**ADDENDUM NO. 3
NEW ELEVATOR
AT MURPHY ELEMENTARY SCHOOL
ROUND LAKE SCHOOL DISTRICT NO. 116
PROJECT NO. 23170**

Board of Education
Round Lake School District 116
884 West Nippersink Road
Round Lake, Illinois 60073

This Addendum shall be part of the Specifications & Requirements for this project and shall be part of the actual contract document to complete the work. There are four (4) items in this Addendum.

E1.0

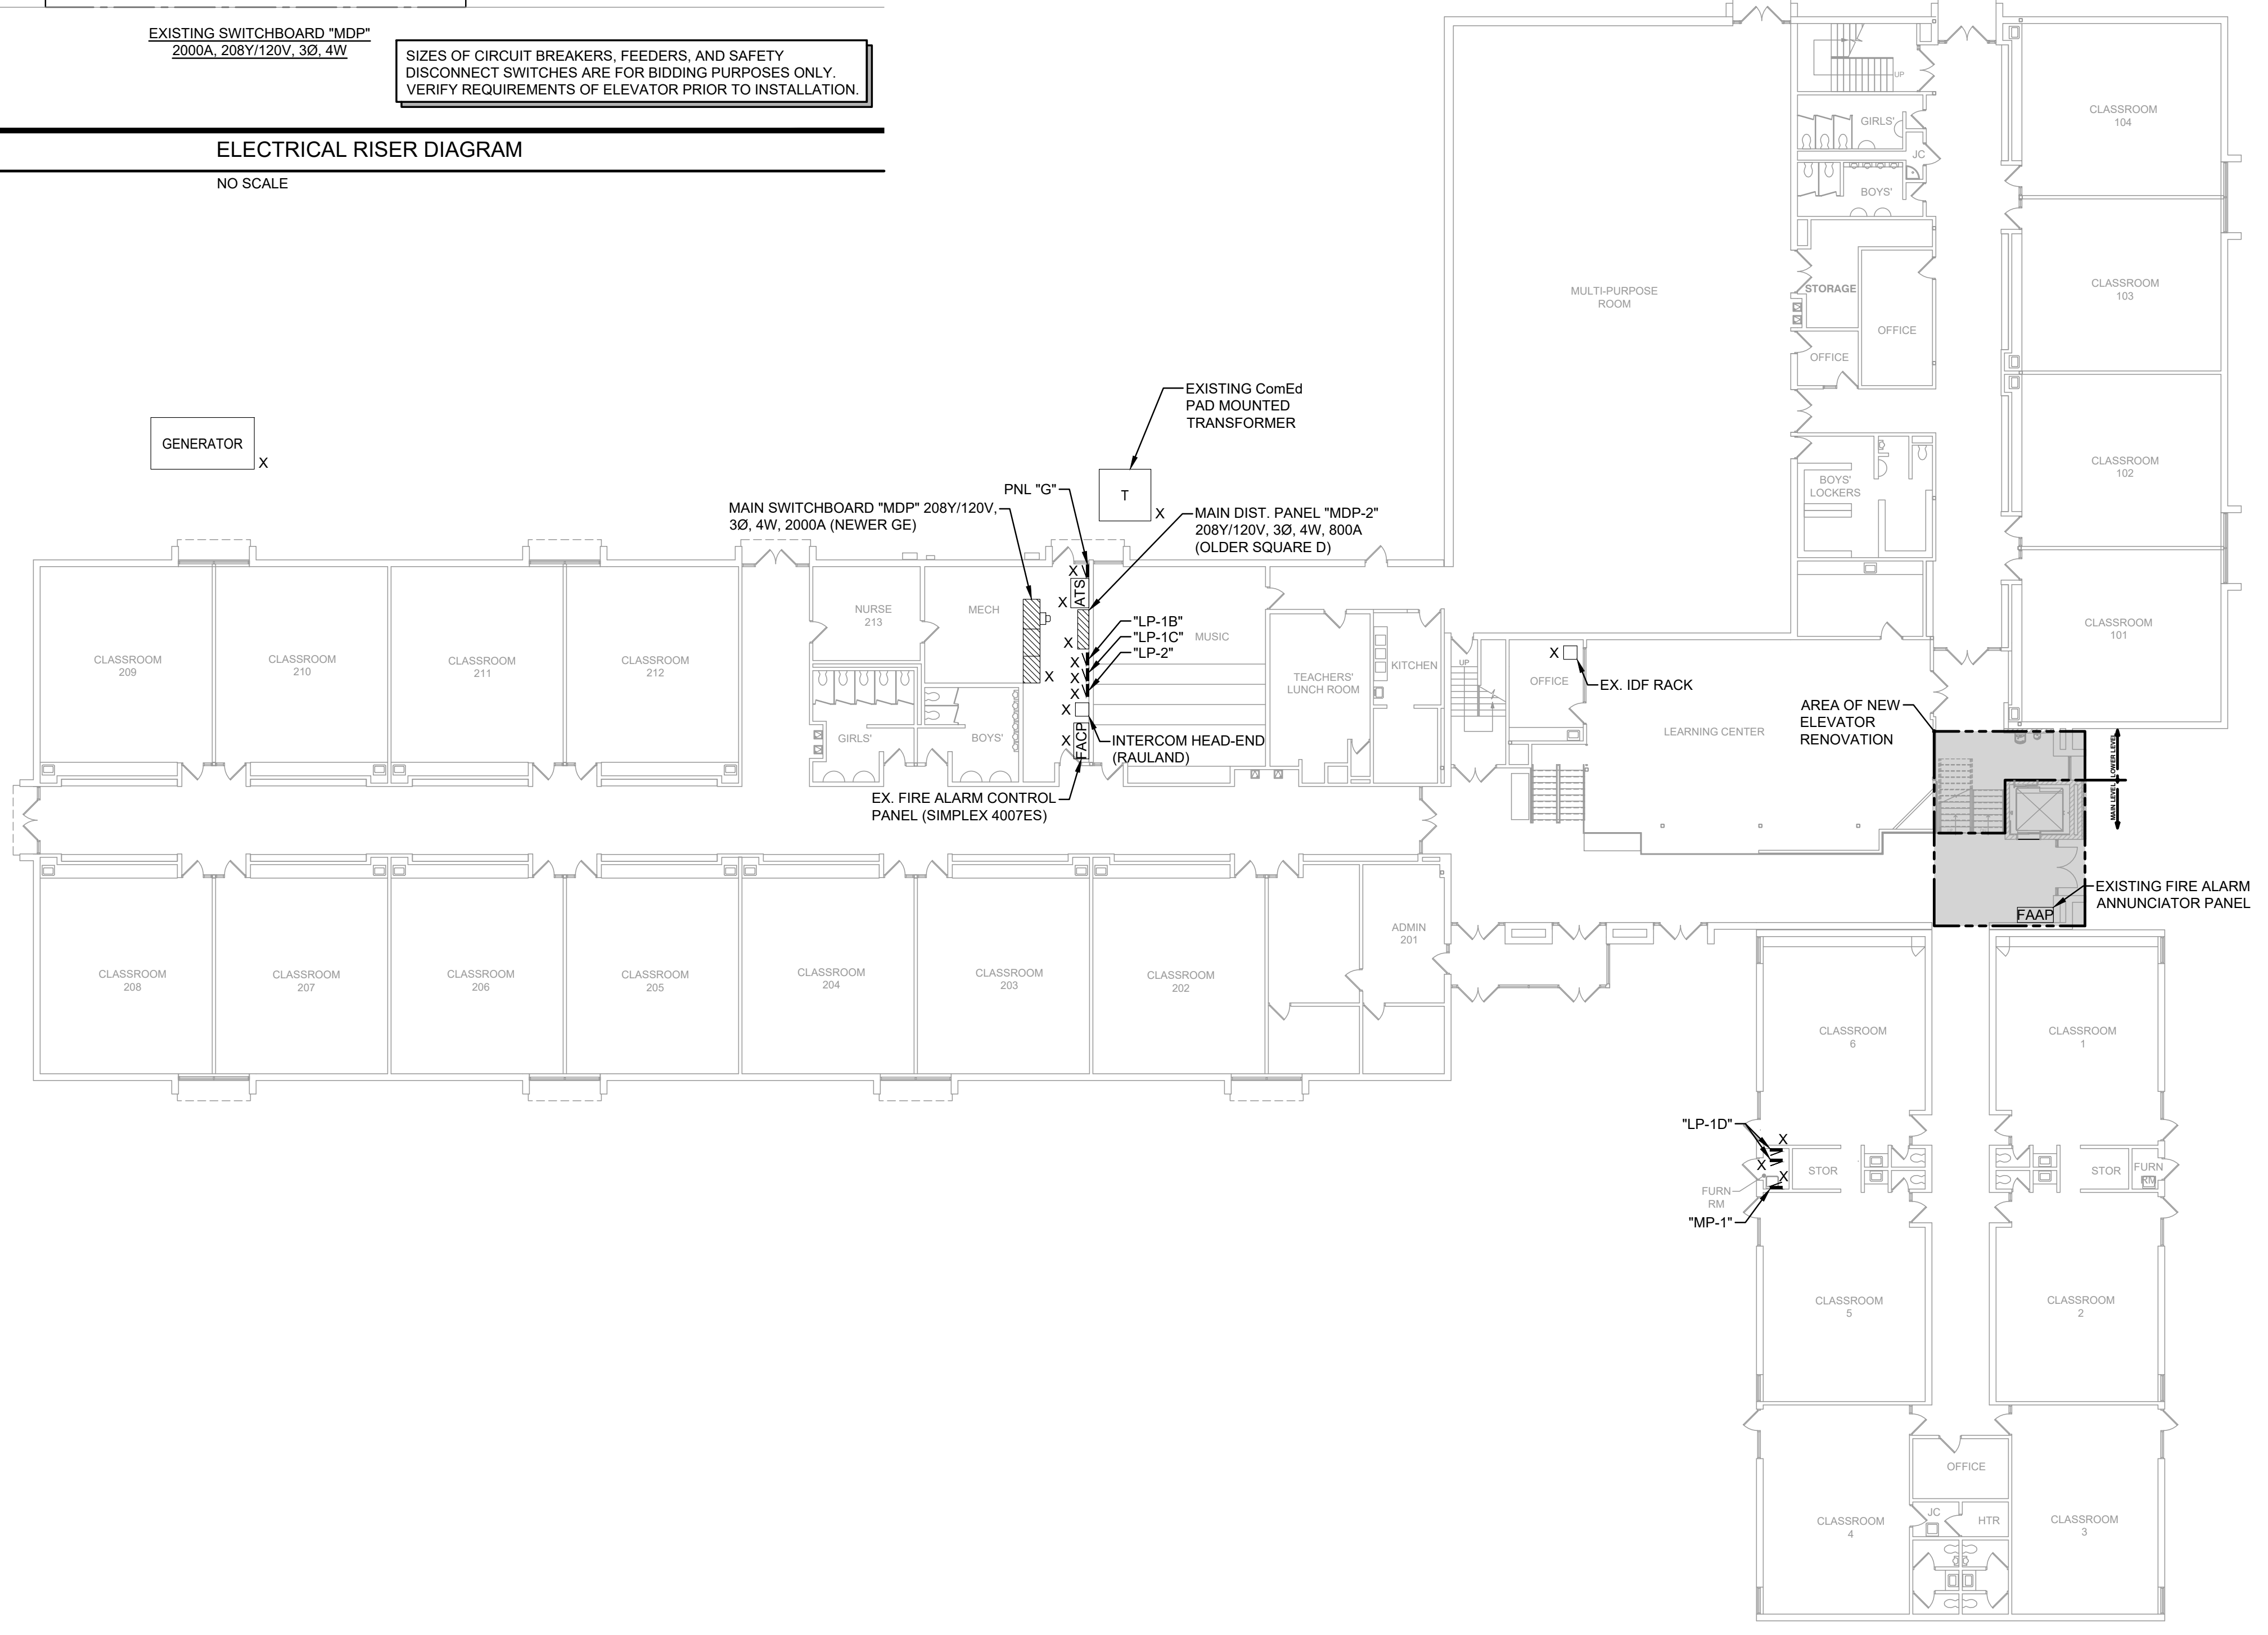
ITEM NO. 3: DRAWINGS, SHEET E1.0, FIRST FLOOR ELECTRICAL COMPOSITE PLAN

1. Change note to phone connection in the Electrical Riser Diagram from "Dedicated digital POTS line. Verify exact requirements with elevator manufacturer." to "Dedicated POTS or digital POTS line. Verify connection type with elevator manufacturer and owner. Verify exact requirements with elevator manufacturer."
2. Refer to attached drawing E1.0 and refer to highlighted items for updates.
